Access Compliance Report Public Rights-of-Way (Curb Ramps)

Main Street: ASCENSO_AVE		Cross Street: ALZA_ST		Location:	NE
ADA ID: RPRK211117131333	Ramp Type: Type 4 - Parallel	Initial Pass/Fail: Fail	Overall Compliance: No	Severity Score:	30
Codes/Mitigation Info/Possible Solution			Field Measurements/Component Compliance

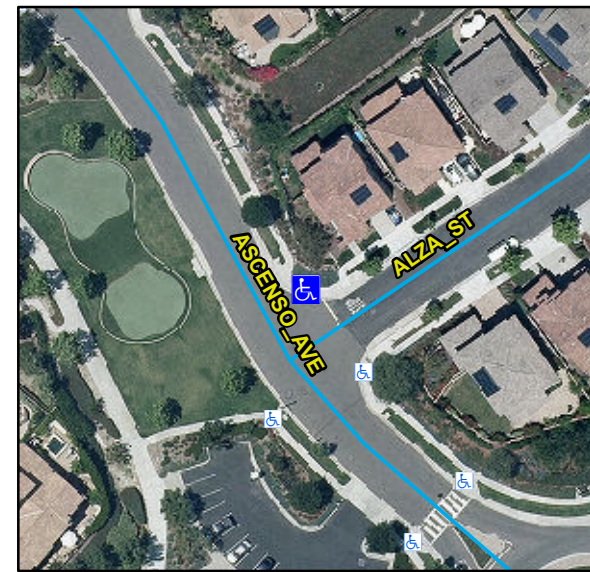
Compliance	Description	Data	Compliance	Description	Data
N/A	Ramp Length LT (in)	112	N/A	Ramp Length RT (in)	111
Yes	Ramp Width LT (in)	54	Yes	Ramp Width RT (in)	54
No	Ramp Run Slope LT (%)	13	Yes	Ramp Run Slope RT (%)	1.9
Yes	Ramp Cross Slope LT (%)	0.5	Yes	Ramp Cross Slope RT (%)	1.1
N/A	Landing Present	N/A	N/A	DWS Provided	N/A
N/A	Landing Length (in)	N/A	N/A	DWS Contrast	N/A
N/A	Landing Width (in)	N/A	N/A	DWS Length (in)	N/A
N/A	Landing Run Slope (%)	N/A	N/A	DWS Full Width	N/A
N/A	Landing Cross Slope (%)	N/A		DWS Offset Type	N/A
N/A	Landing Movement Obstructed?	N/A	N/A	DWS Offset Left (in)	N/A
	Landing Movement Type	N/A	N/A	DWS Offset Right (in)	N/A
N/A	Landing Shared	N/A			
N/A	Clear Space	Yes			
N/A	Clear Space To Crosswalk (in)	N/A			
N/A	Marked Crosswalk 1	No	N/A	Marked Crosswalk 2	No
	Crossing 1 Direction	W		Crossing 2 Direction	S
	Marked Crosswalk 1 Width (in)	N/A		Marked Crosswalk 2 Width (in)	N/A

Remove & Replace Curb Ramp With Two New Directional Ramps or Equivalent.

R304.3.2, STD 1115
